State Significant Development Application Response to Submissions

SSD-72700708 Affordable Housing Development
25-27 Boyd Street, Tweed Heads

Prepared for Homes NSW

Figure 3 Original Versus Amended Design of the Boyd Street Frontage

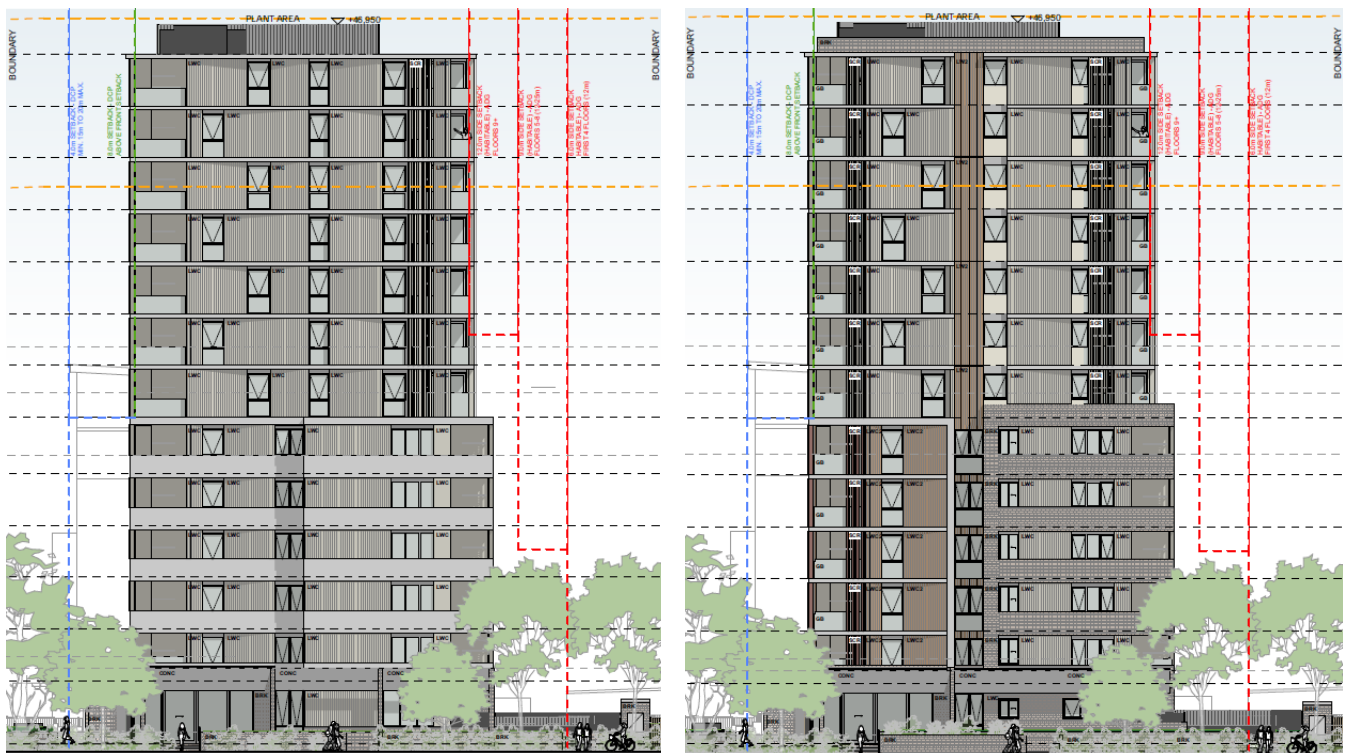
- The materiality of the building facades has been amended to differentiate the street wall and tower and provide a more strongly defined corner. This amendment also reduces the concrete slab banding with greater breaks introduced via vertical glazing, also reducing the impacts of weathering and staining on concrete finishes.

4.1.1 Façade Articulation and Materiality

The amendments made to the facades of the proposed development are illustrated in **Figure 3** and **Figure 4**.

The amended architectural plans have increased the use of glazing materials to enhance solar access to the units, and further adjustments have been made to minimise concrete banding on the façades. These changes have positively impacted the façade design without making significant changes to the design, which was originally assessed as being of a high quality. The updated design reflects a building façade and materiality that differentiates the street wall and tower façade and re-instates a strong defined corner treatment. The refinements to the façade materiality in response to the NSW GA's feedback maintains the original design integrity whilst introducing additional benefits such as improved privacy and increased solar access.
